Acoustic Report

**St George Hospital Acute Services Building
Redevelopment**

Schematic Design Report

ARCHITECTURE
 GA Plans - Level 5 Zone 1

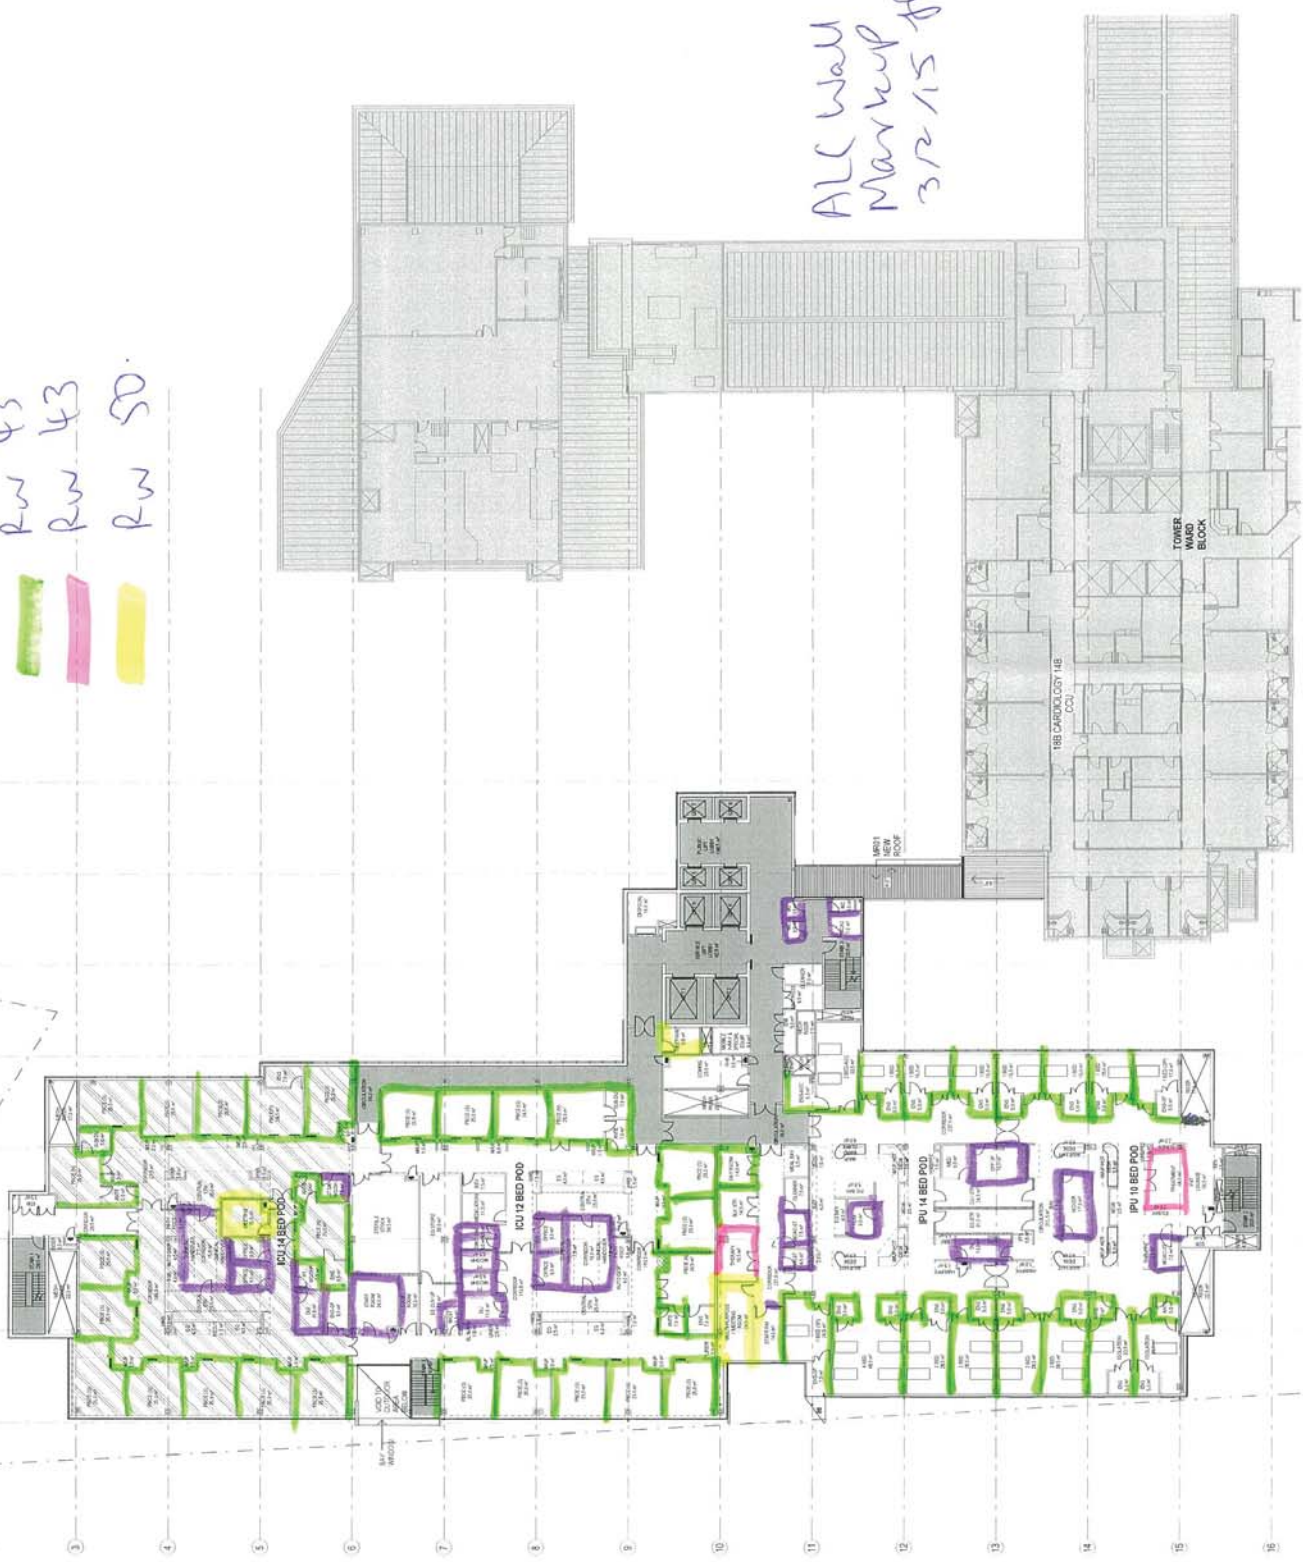
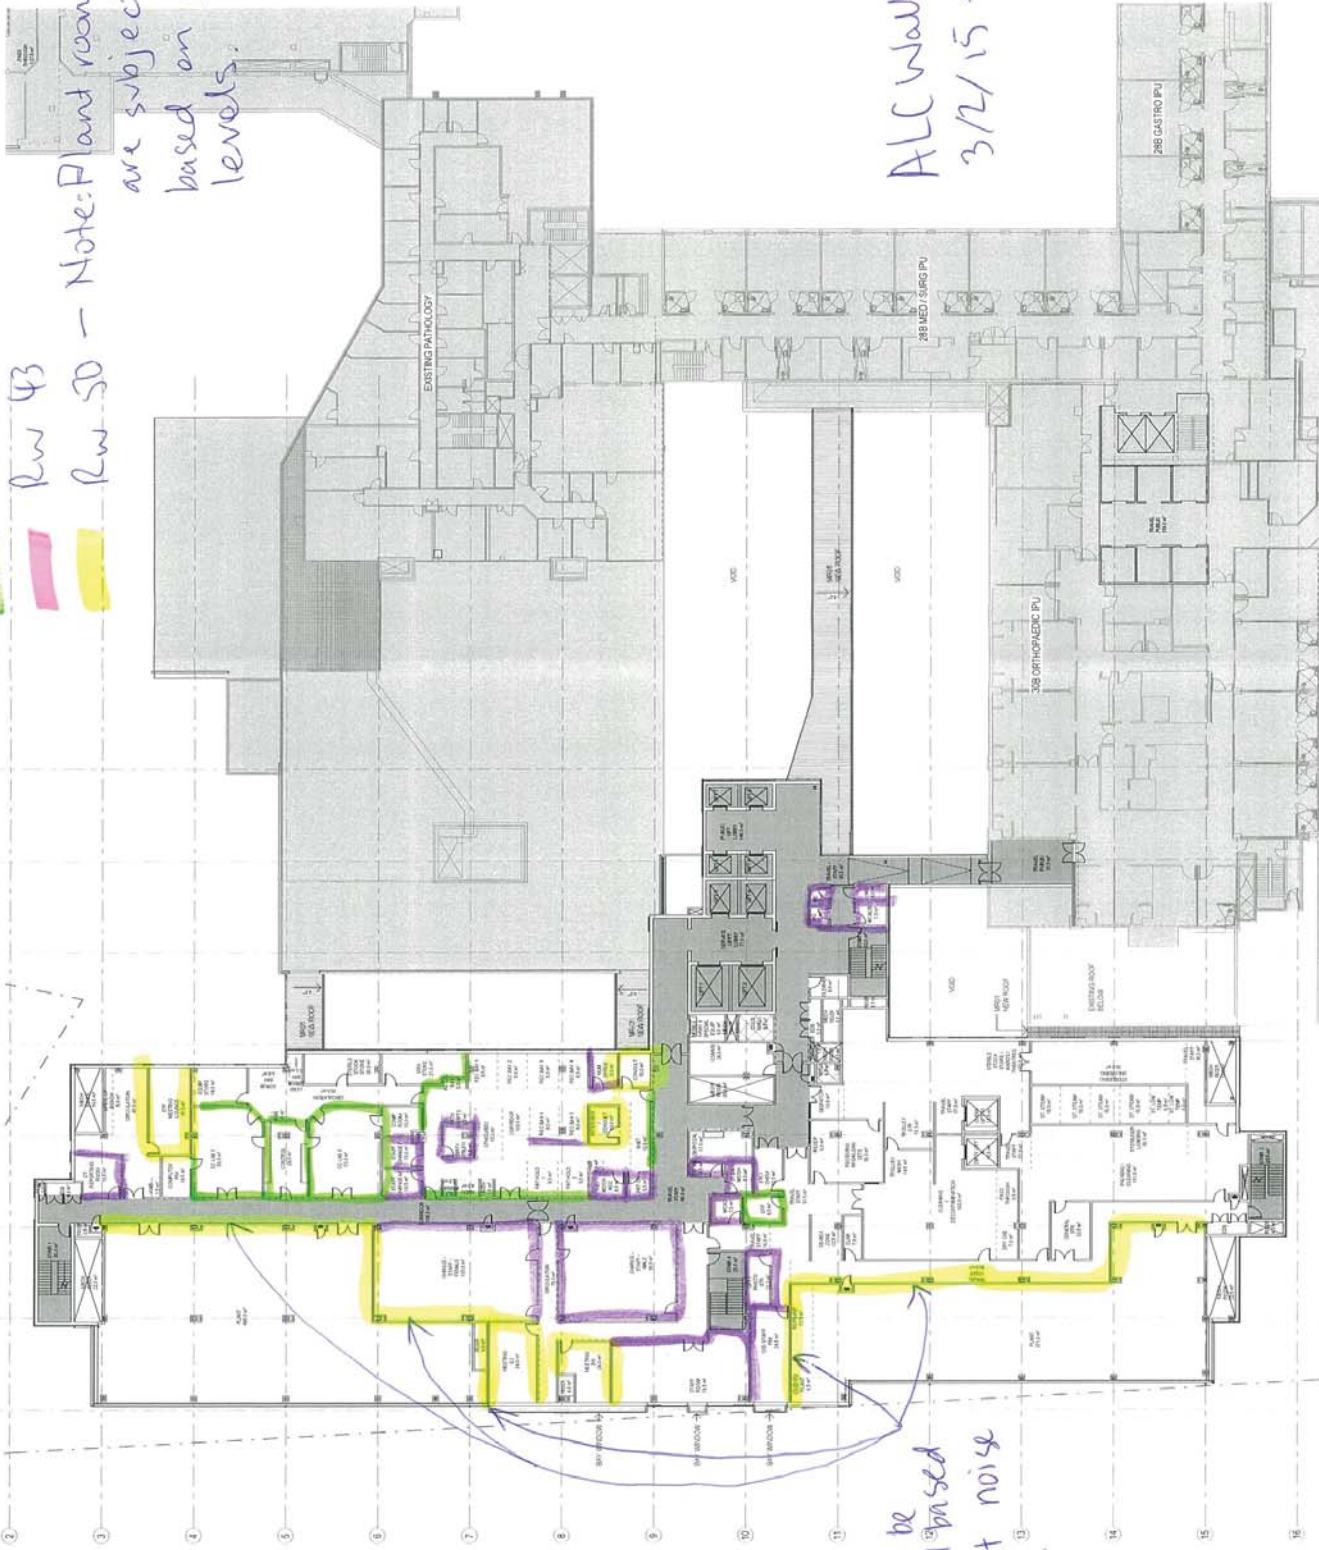
Rw 37
 Rw 43
 Rw 43
 Rw 50

ALL Wall Markup
 3/2/15 JP

Note: Plant room walls are subject to design based on plant noise levels.

Wall to be designed based on plant noise levels.

ST GEORGE HOSPITAL ACUTE SERVICES BUILDING REDEVELOPMENT
ST GEORGE HOSPITAL (G06ARH) NSW 2217
ARCHITECTURE
GA Plans - Level 1 Zone 1

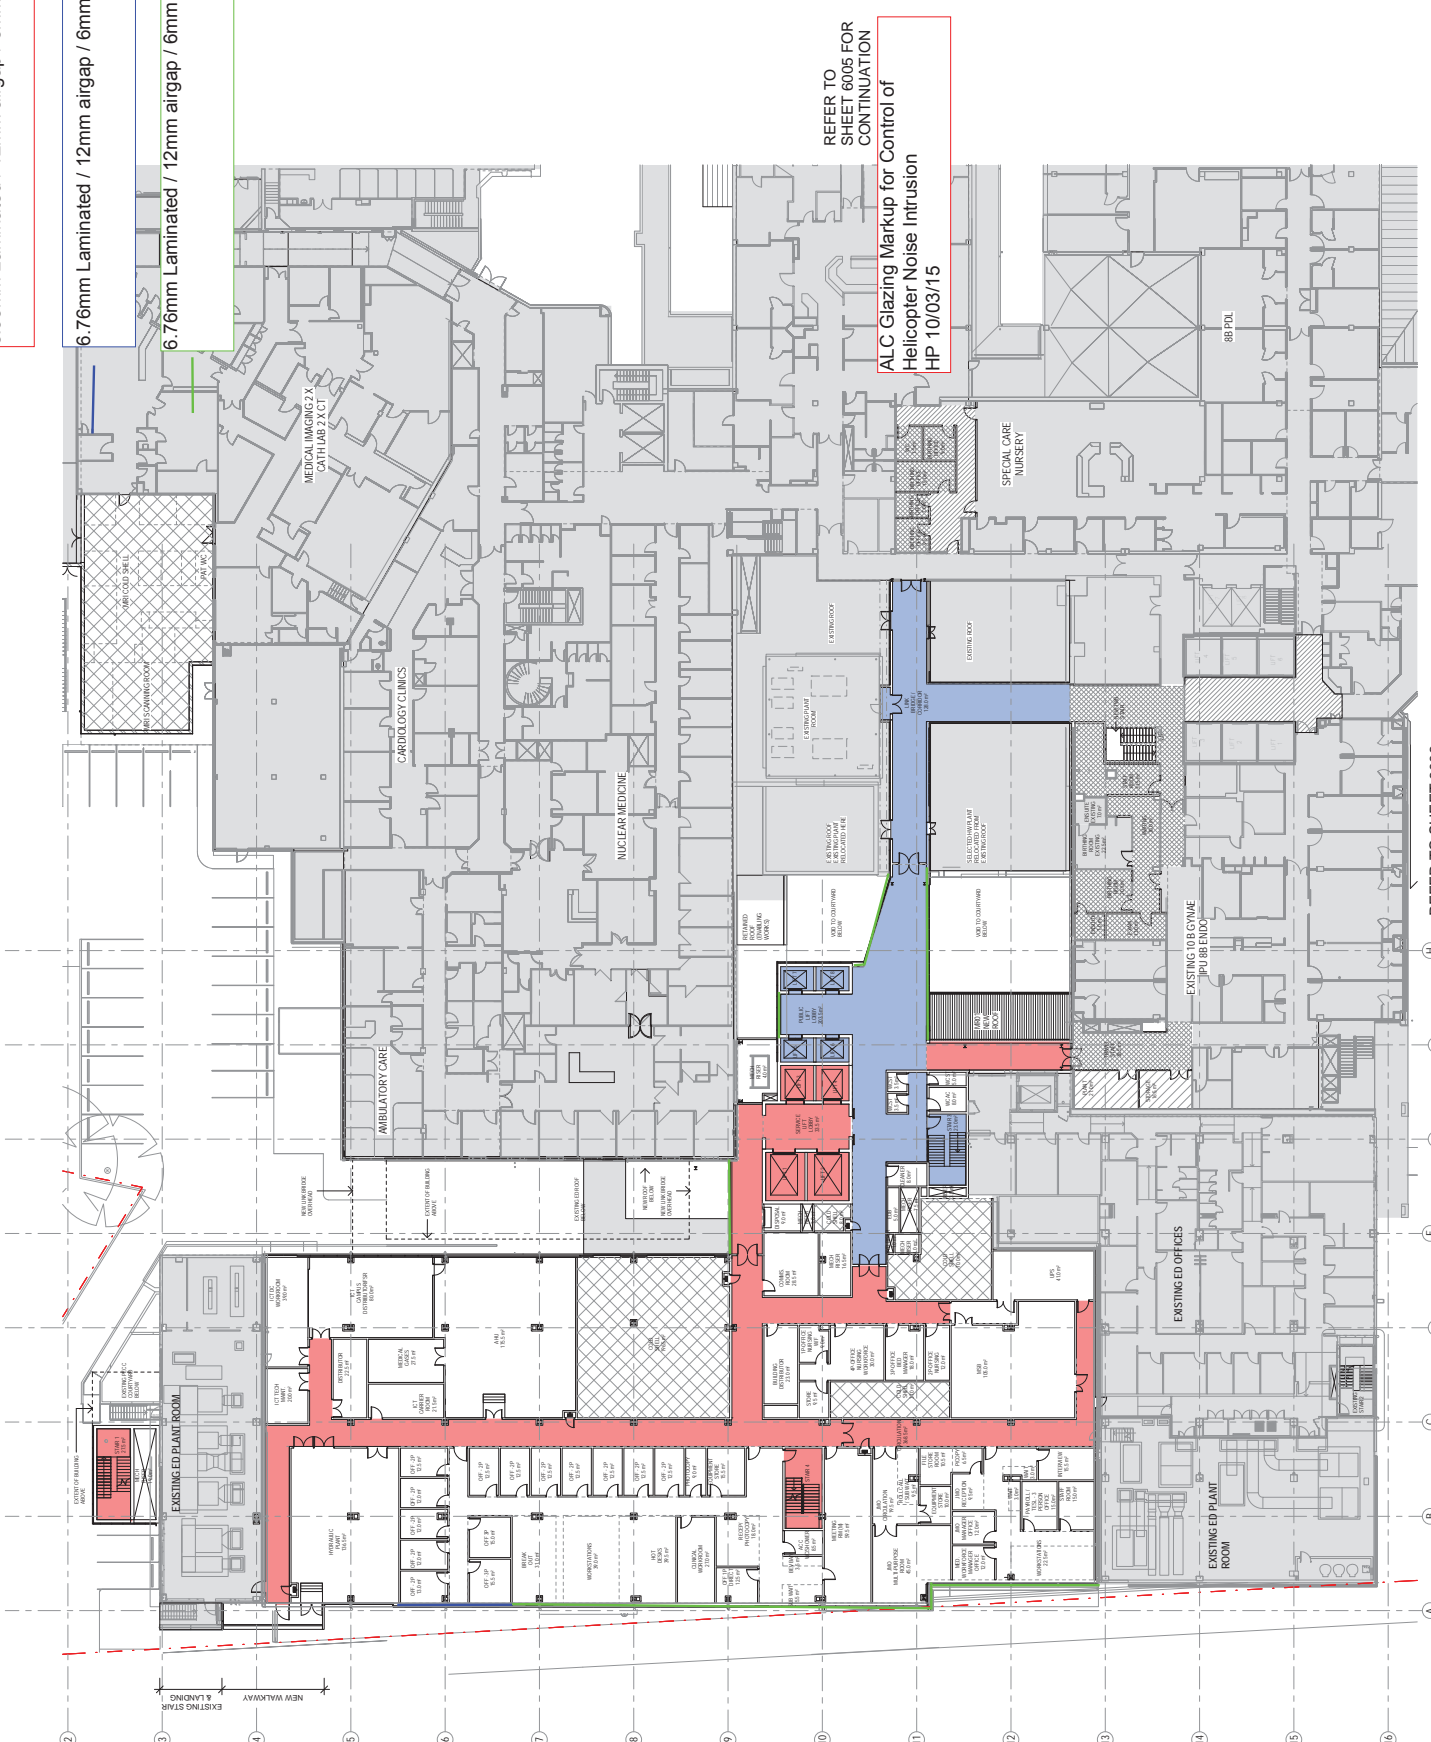
ALC Glazing Markup for Control of Helicopter Noise Intrusion HP 10/03/15

ST GEORGE HOSPITAL ACUTE SERVICES BUILDING REDEVELOPMENT
ST GEORGE HOSPITAL (GOUGHAN NSW 2217)
ARCHITECTURE
GA Paris - Level 2 Zone 1

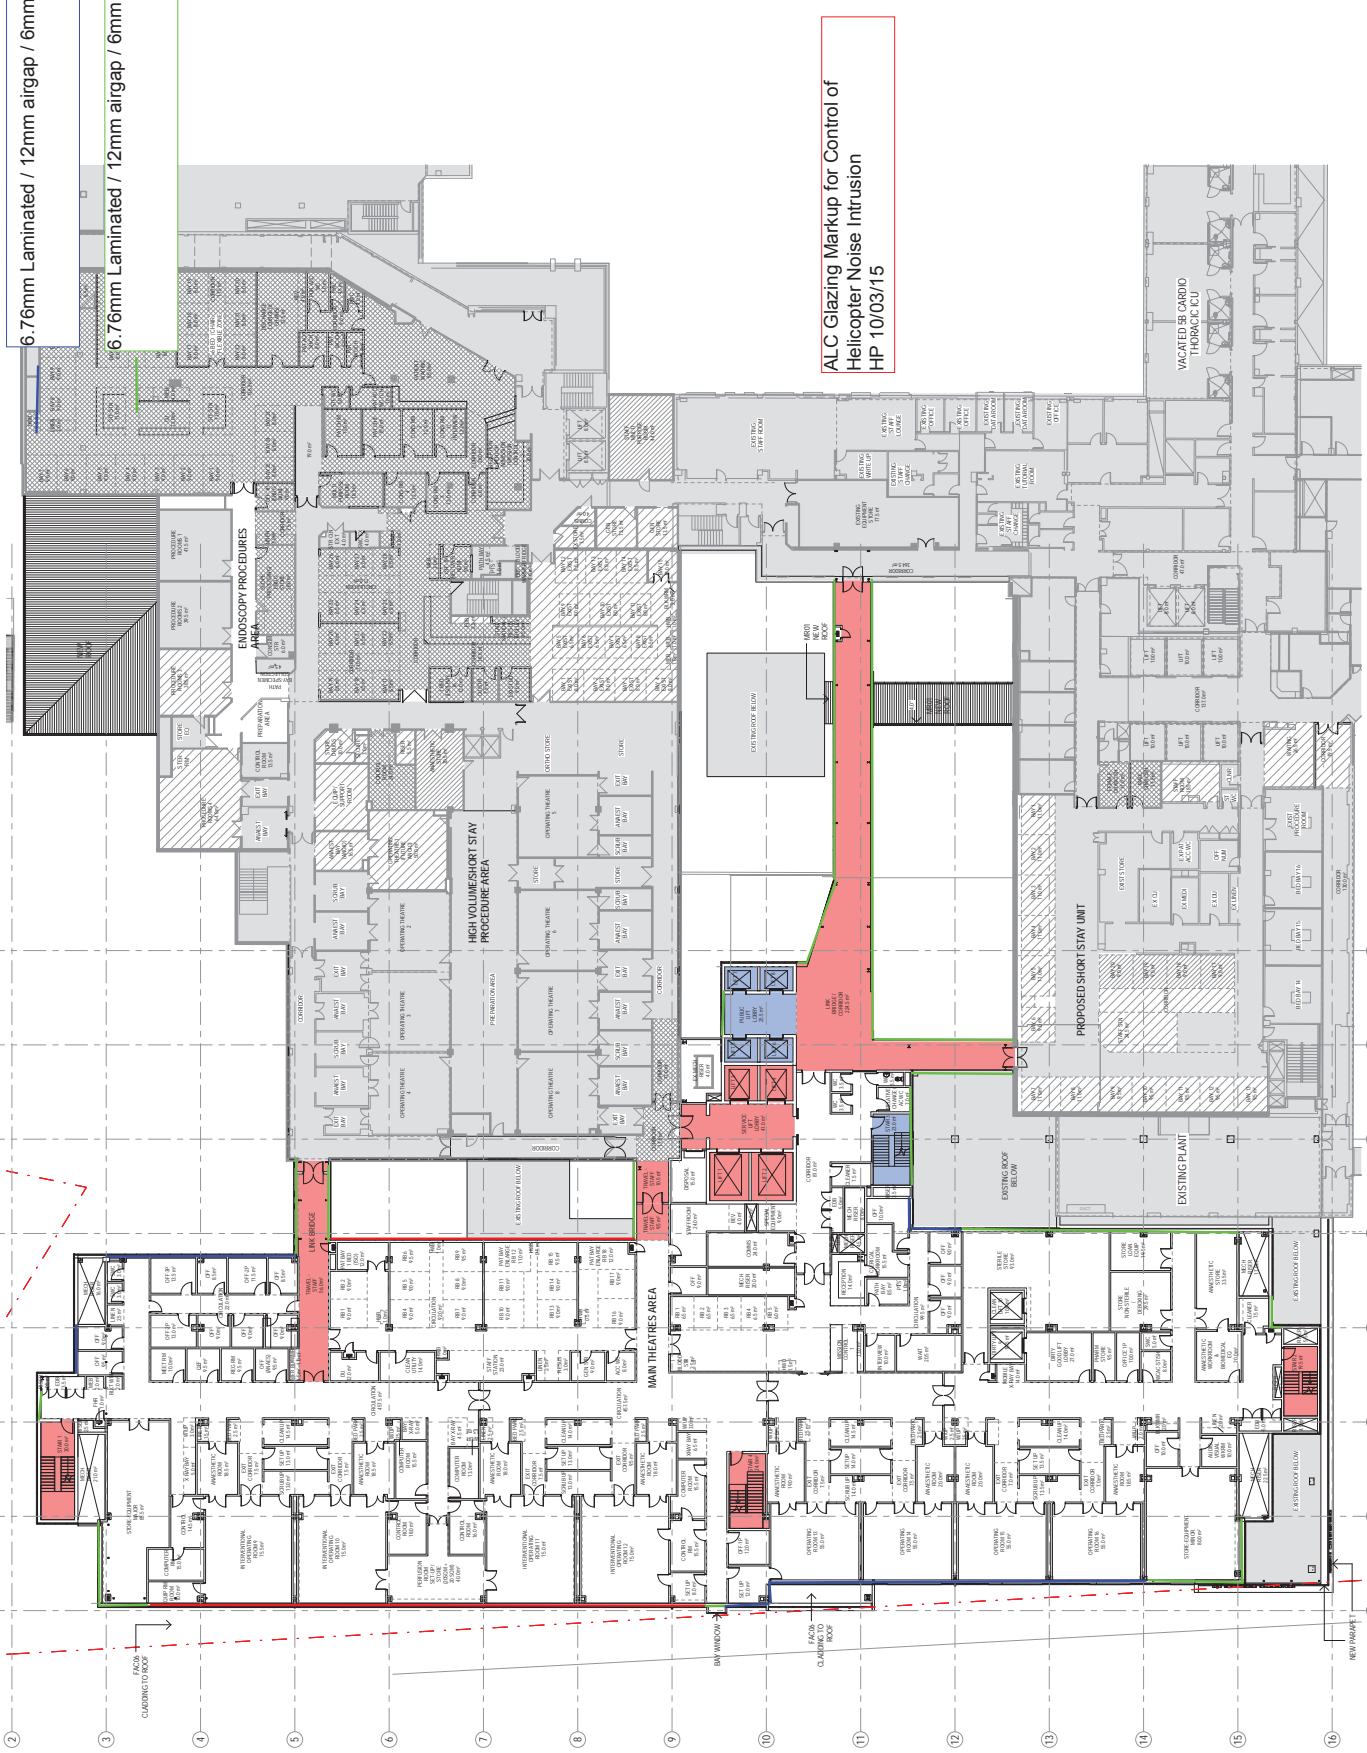
8.38mm Laminated / 12mm airgap / 8mm

PROJECT: ST GEORGE HOSPITAL ACUTE SERVICES BUILDING REDEVELOPMENT
 CLIENT: ST GEORGE HOSPITAL (KOCORAH) NSW 2217
 TITLE: ARCHITECTURE
 GA Plans - Level 3 Zone 1

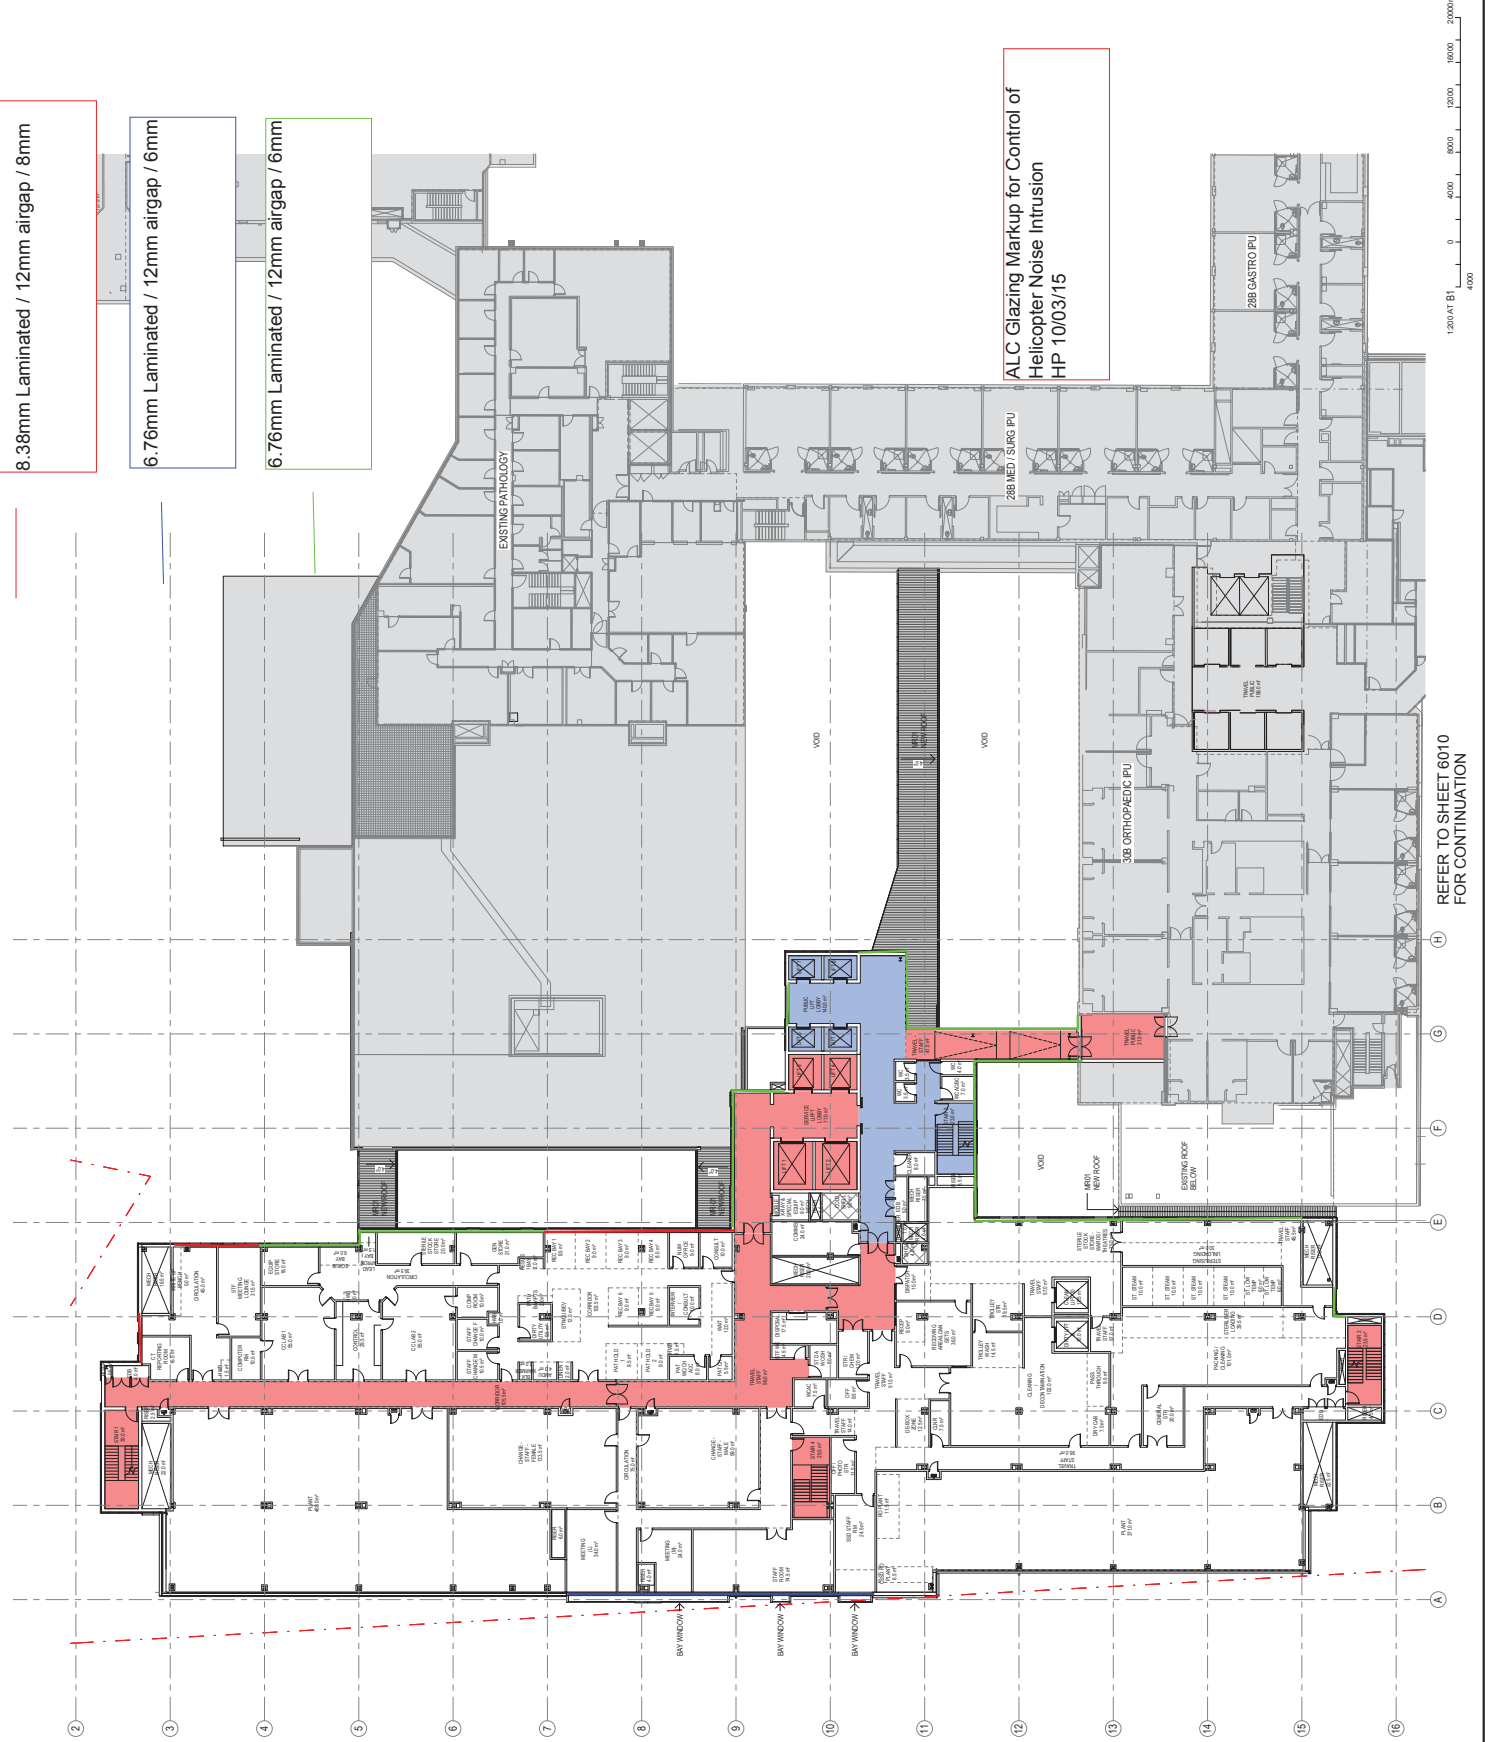
6.76mm Laminated / 12mm airgap / 6mm

6.76mm Laminated / 12mm airgap / 6mm

ALC Glazing Markup for Control of Helicopter Noise Intrusion
 HP 10/03/15
